**Date:** August 19, 2015

**RE:** Proposal from Flambeau Mining Company (FMC) for an “Artificial Waterbody Connected to a Navigable Stream”

**Docket Number:** IP-NO-2015-55-01907

Figure 2. Original Biofilter System at Flambeau Mine Site (prior to conversion of Biofilter to Infiltration Basin in 2012).

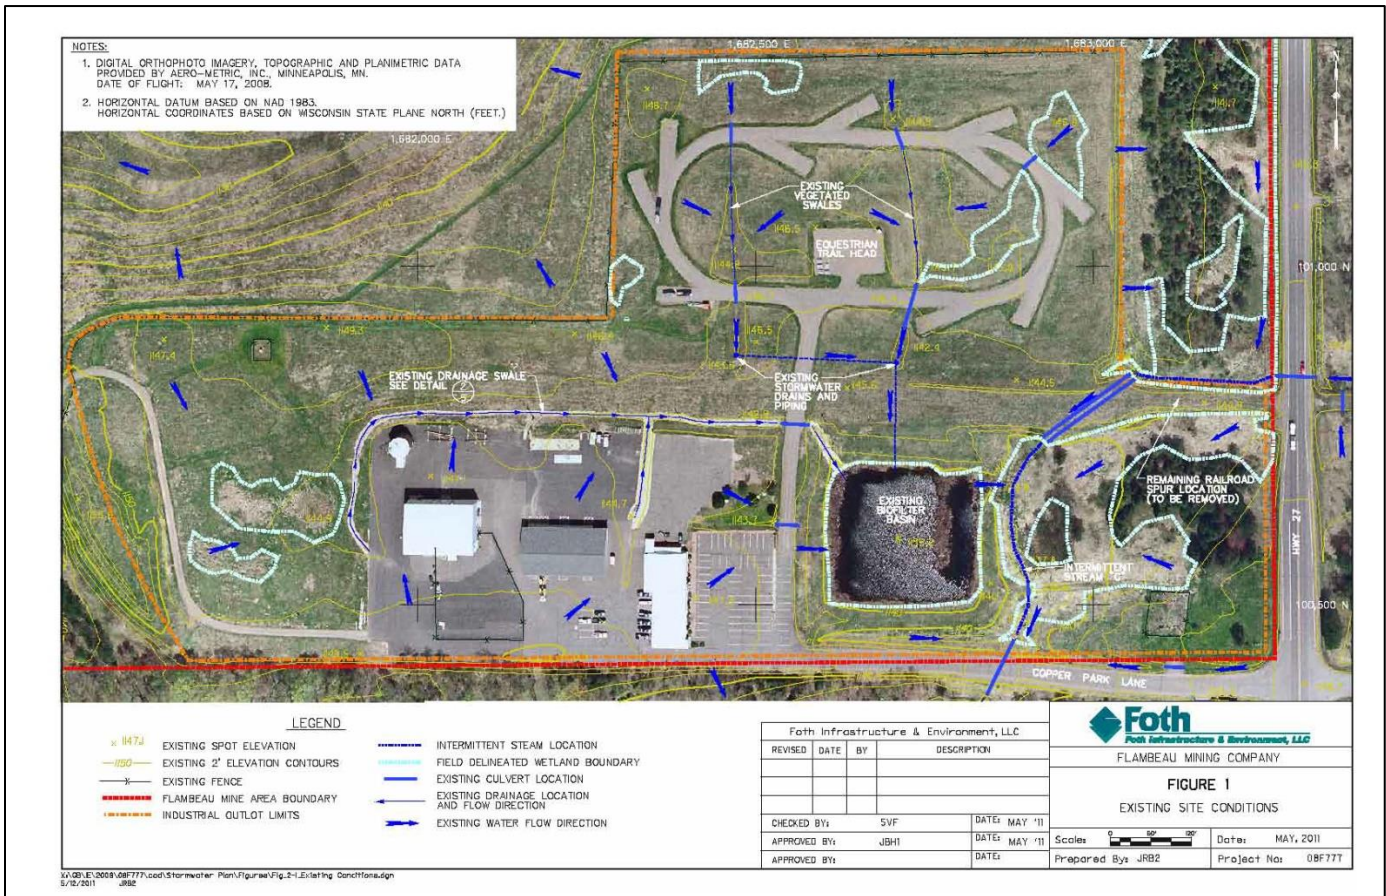
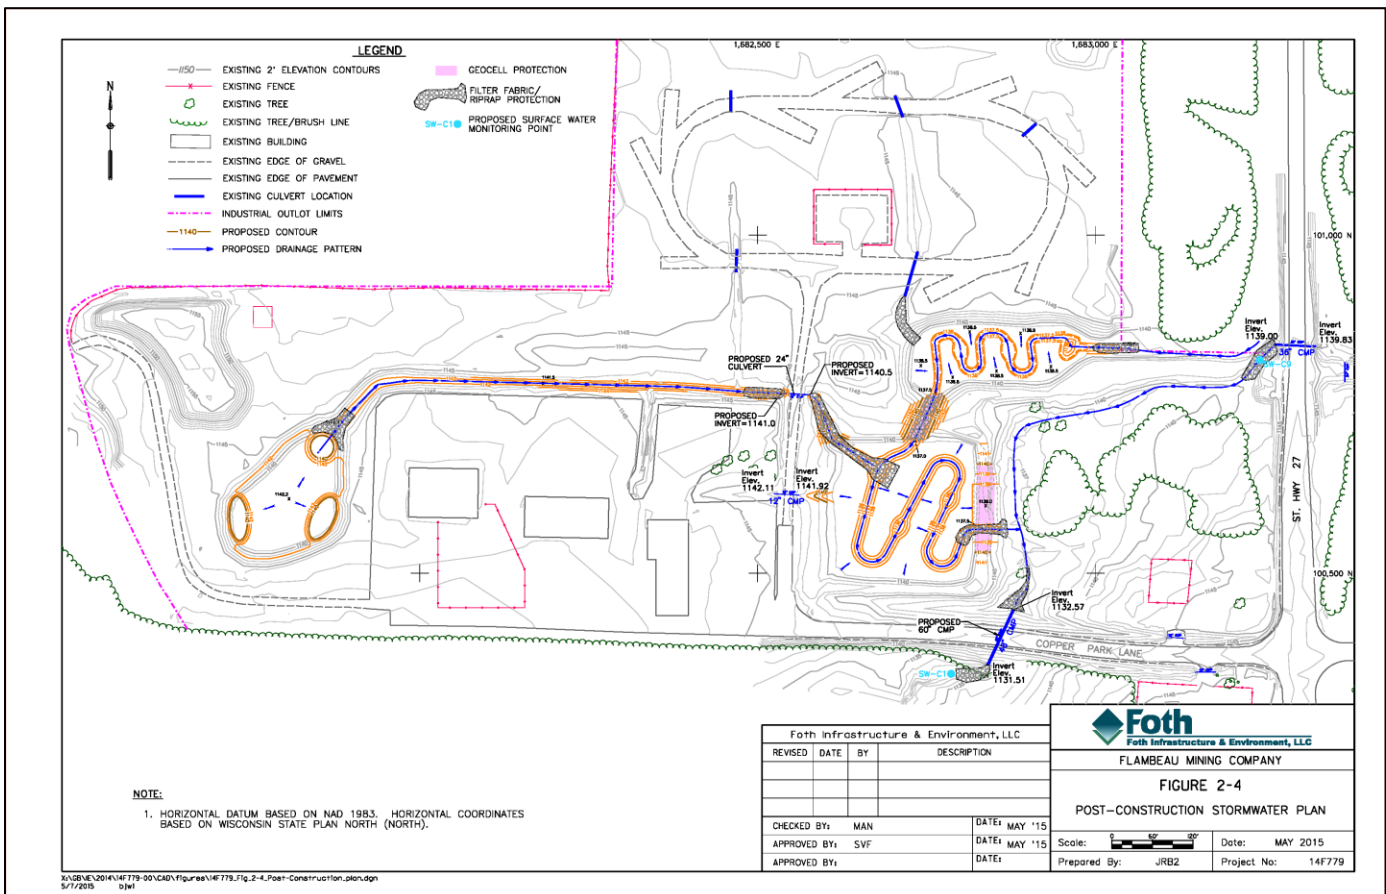
**ANALYSIS.** The new stormwater management plan proposed by FMC for the southeast corner of the Flambeau Mine site is a throw-back to the original biofilter management plan that was found, by the courts, to be discharging contaminated runoff to a water of the United States. The "new" plan calls for the runoff to be collected in shallow man-made ponds and ditches (analogous to the original biofilter and even proposed for the exact same location), allowed to overflow into the Stream C channel north of Copper Park Lane (just like the overflow from the original biofilter did) and ultimately exit the property through a large culvert (60 inches in diameter x 90-100 feet long) that is directly connected to Stream C, both north and south of Copper Park Lane (just like when the original biofilter was in place, except the culvert was 48 inches in diameter).

You can see how the "new" plan is a throw-back to the old one by comparing the schematics of the two systems shown on the following page (enlarged copies of the schematics are also included in **Appendix-2**). The first schematic, taken from the *Copper Park Business and Recreation Area Work Plan* (May 2011), shows the original biofilter system at the Flambeau Mine site, prior to conversion of the biofilter to an infiltration basin in 2012. The second schematic, taken from the *Copper Park Business and Recreation Area Work Plan Supplement* (May 2015), the plan that is the subject of the present hearing, shows the proposed "new" stormwater management plan.

Basically, the only change FMC has made to its original biofilter plan is in the *wording*. Instead of calling the east basin a “biofilter with a finger peninsula and outlet,” they now refer to it as a system of “shallow pools with a connecting ditch and an overflow structure/weir.” If it looks like a duck, swims like a duck, and quacks like a duck, then it’s a duck.

Since Foth’s own schematics show FMC’s “new” surface water management plan to have the same discharge pattern involving Stream C, the Wisconsin DNR is now in a position to correct the earlier mistake by requiring the company to secure a WPDES permit, and that is what I am asking the Department to do.

Even though FMC has changed the *names* of the various components of its runoff discharge system, company diagrams show no substantive difference between the original biofilter system and what is now proposed. What’s more, the runoff historically has proven to be contaminated (as proven by environmental monitoring data on record with the Department), and Stream C is in need of added protection due to its impaired status.

2. So that the same mistake exposed in the CWA case cited above is not repeated, I am asking the Wisconsin DNR to require FMC to obtain a WPDES permit for the discharge of potentially contaminated runoff from its detention basin/culvert system to Stream C.
